CONSTRUCTION SUMMARY

381 - 2 - The Barossa 3 (38-3) Elev B

Lot #381

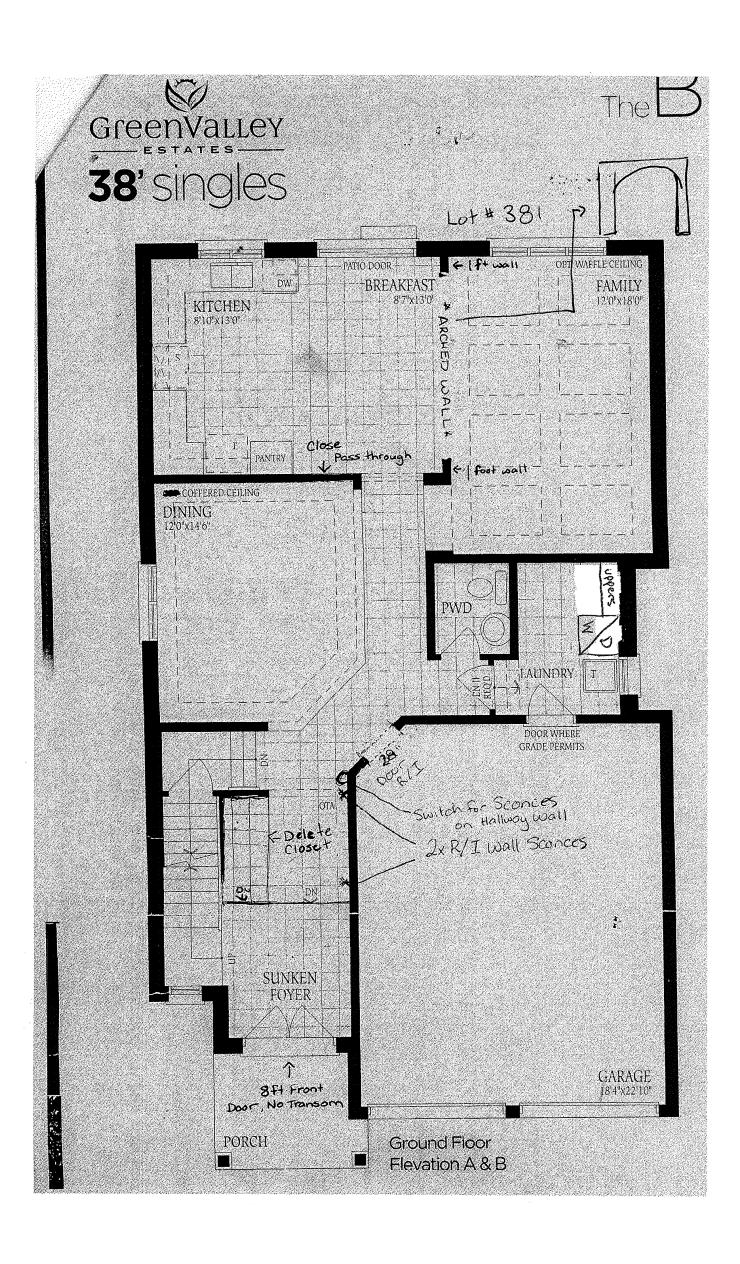
Inv. 637	1 - ADDITIONAL RAILING UPGRADE 2 LEVEL 3 - GREY
	(FOR EXTRA RAILING EXPOSED BY REMOVING THE FRONT CLOSET)
Line 5979	Note:
16Feb16 / 28Apr16

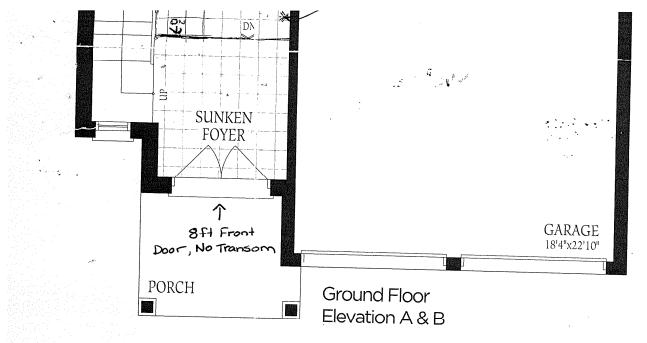
Arch to look like this
